EMANUEL ENGINEERING, INC.

RE: Roof Snow Loads
Moharimet Elementary School
Oyster River Cooperative School District
Madbury, NH

This report summarizes our observations and recommendations.

Room 155 - vertical crack at joint of 2 dissimilar walls

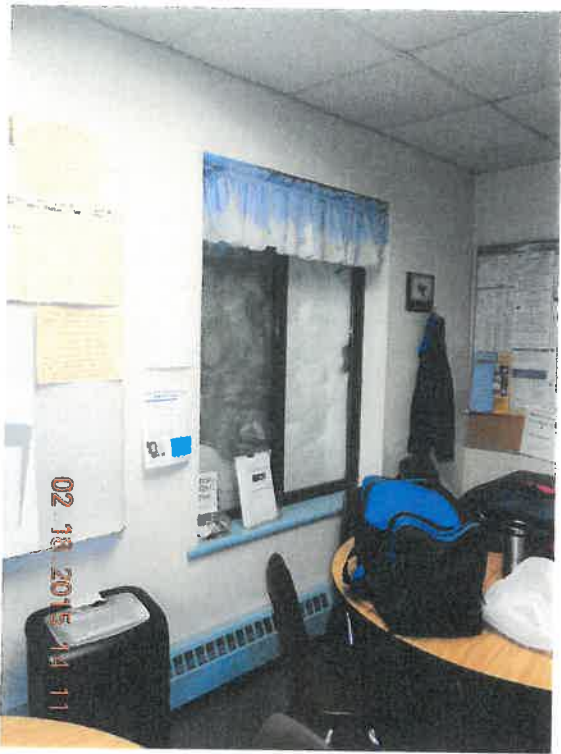
Room:	Observations – Comments:
155	Observed vertical crack at juncture of masonry wall and interior drywall face of the exterior metal framed wall. Both walls are non-load bearing and independent of each other. Believed to be unrelated to current snow load conditions and crack is not of structural significance. Concerned with snow loading resulting from snow piling against window units.

Room 130 - drywall crack

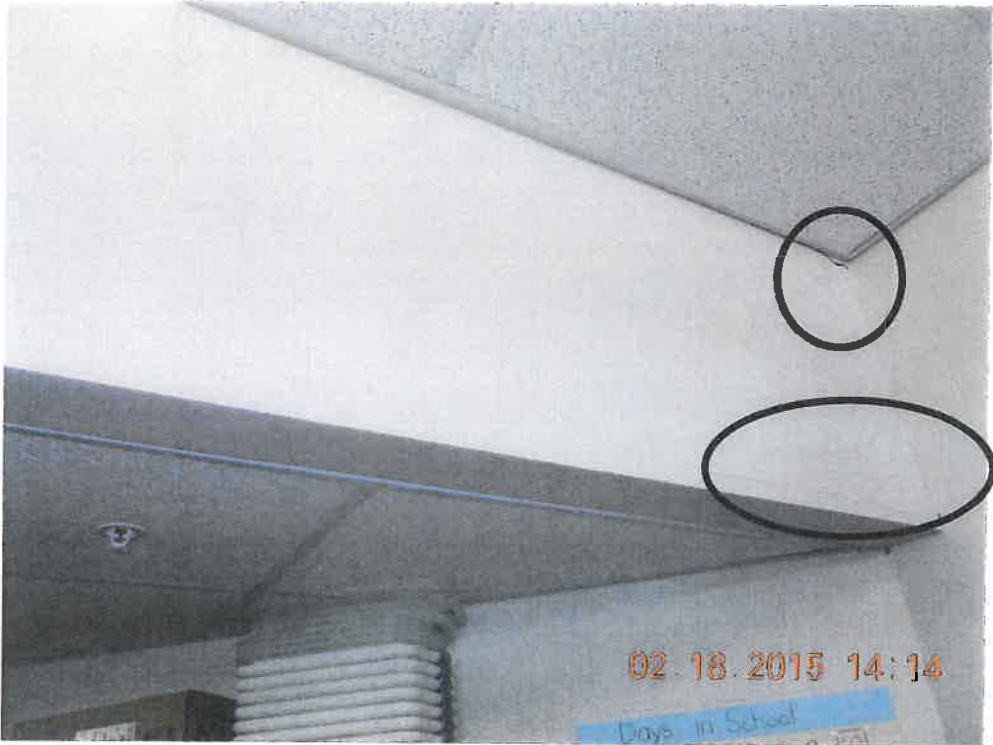
130	Drywall cracking in corners of soffit opening, non-load bearing wall. Drywall track was fastened directly to the roof bar joists without using proper deflection track. Soffit cracks indicate snow loading and normal deflection of bar joists, not damage to structural elements. Snow was removed from roof area above prior to arrival. No visible signs of structural distress.
137	Drywall cracking in corners of soffit opening, non-load bearing wall. Drywall track was fastened directly to the roof bar joists without using proper deflection track. Cracks indicate snow loading and normal deflection of bar joists, not damage to structural elements. Snow was removed from roof area above prior to arrival. No visible signs of structural distress.
138	Drywall cracking in corners of soffit openings and corners of non-load bearing wall. Fire protection sprinkler heads escutcheons protruding below ceiling tiles more than normal. Drywall track was fastened directly to the roof bar joists without using proper deflection track. Sprinkler head movement and stress cracks in drywall indicate snow loading and deflection of bar joists, not damage to structural elements. No visible signs of structural distress.

- Drywall cracks may be repaired but will reoccur when excessive snow loads occur on the roof unless the light gage metal framing is modified by using proper deflection tracks at the top of the wall above the observed cracks.
- All roof drains shall be kept free of snow to allow for snow melt.

**Room 114 - drywall cracked at HVAC opening
caused by roof joists movement.**

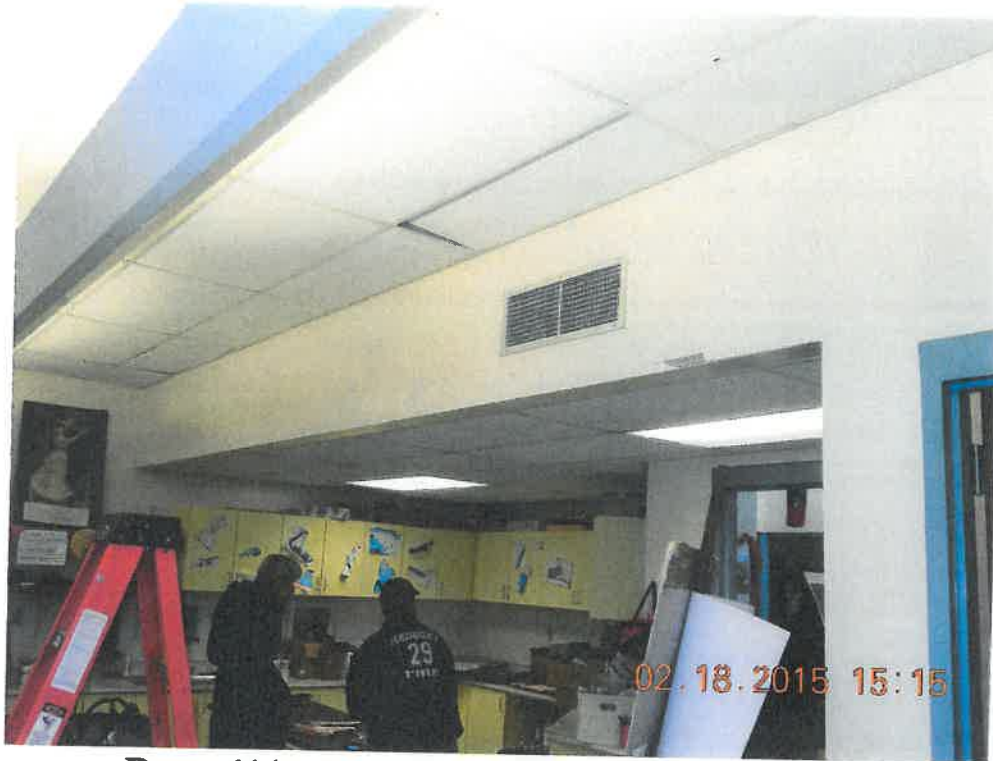
114	Stress cracks in drywall were observed around HVAC ductwork. Drywall track was fastened directly to the roof bar joists without using proper deflection track. No signs of structural distress.
118	Stress cracks in drywall were observed in wall at a drywall opening and around HVAC ductwork. Fire protection sprinkler head escutcheons protruding below ceiling tiles more than normal. Sprinkler heads and stress cracks in drywall indicate snow loading and normal deflection of bar joists, not damage to structural elements. No visible signs of structural distress.
East Commons	Snow observed above skylight windows indicating heavy load in recessed roof area. Measurements were taken from the building interior floor elevation to the bottom of exposed steel bar joists. No notable deflections were observed. No signs of structural distress.
119	Stress cracks in drywall were observed in wall at a drywall opening and around HVAC ductwork. Ceiling track was observed to be slightly deformed at the wall. Fire protection sprinkler head escutcheons protruding below

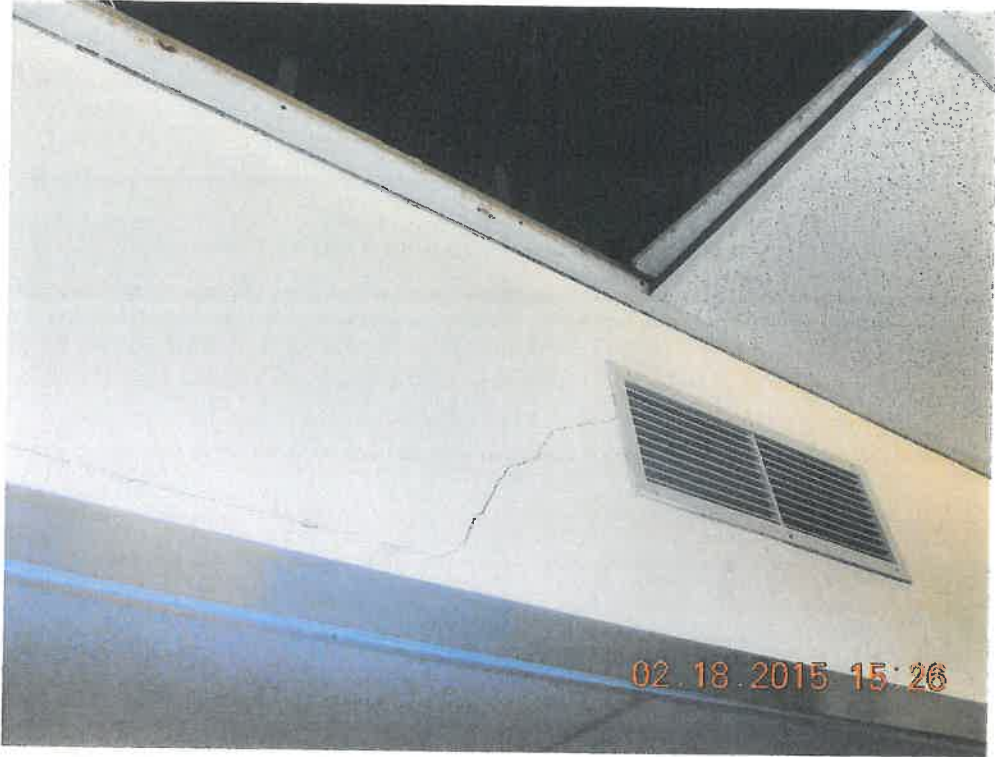
Sprinkler head moves downward as roof joists deflect downward.

Cracked drywall caused by improper deflection track.

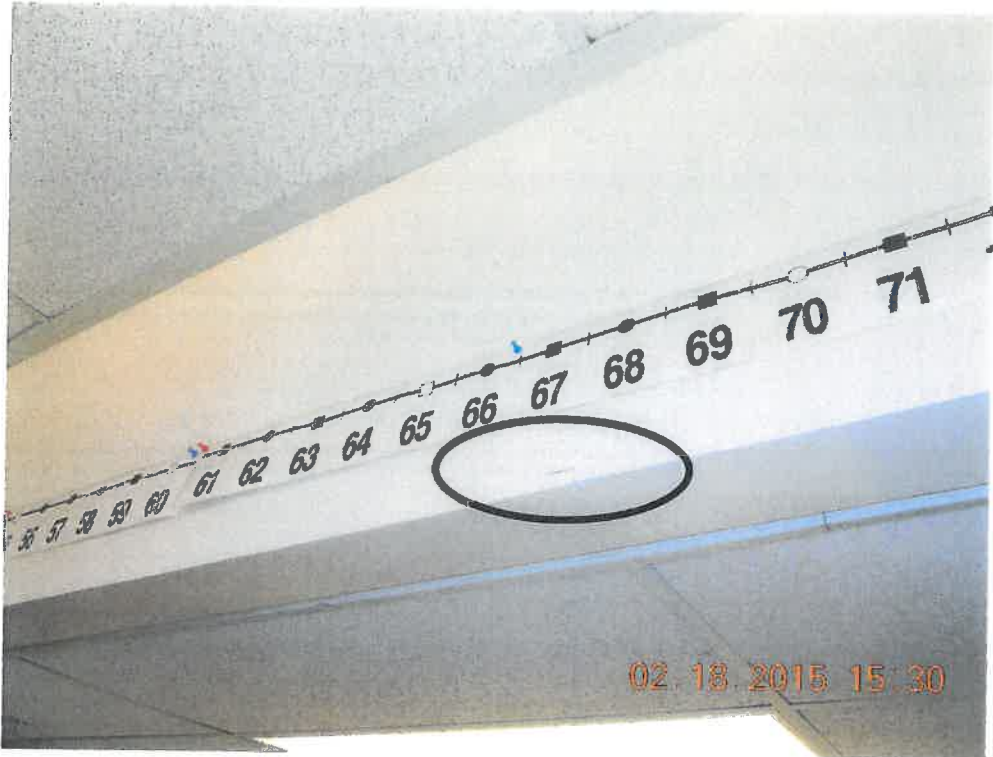
Wall track fastened directly to steel bar joist.

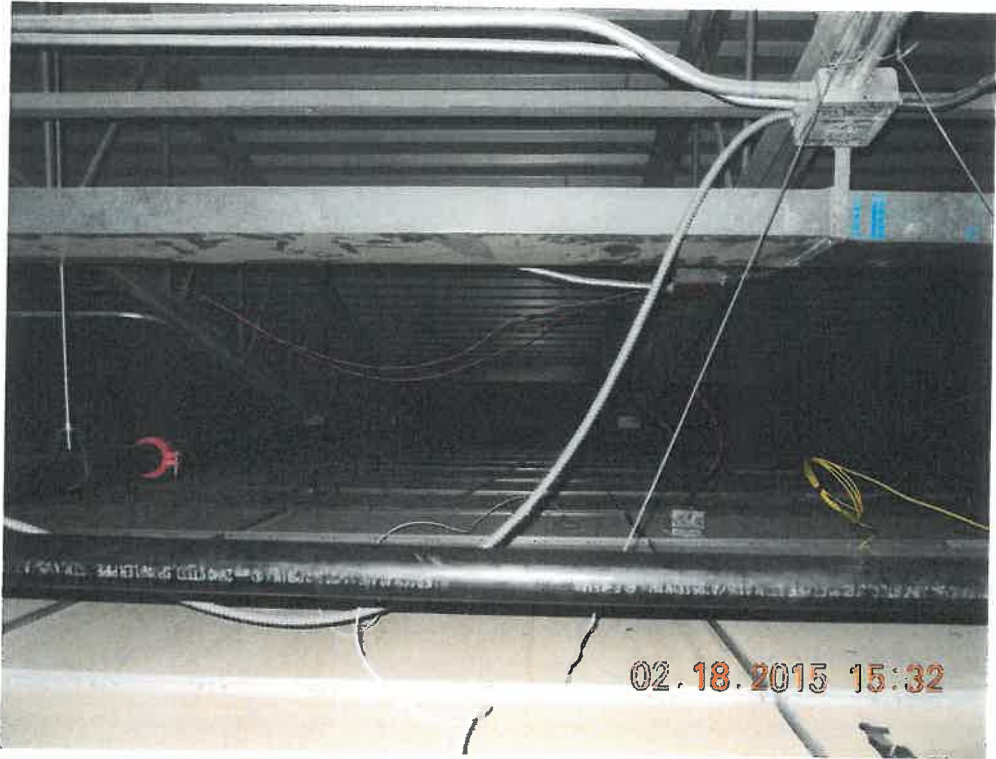
Metal stud wall allows for no movement of roof joists.
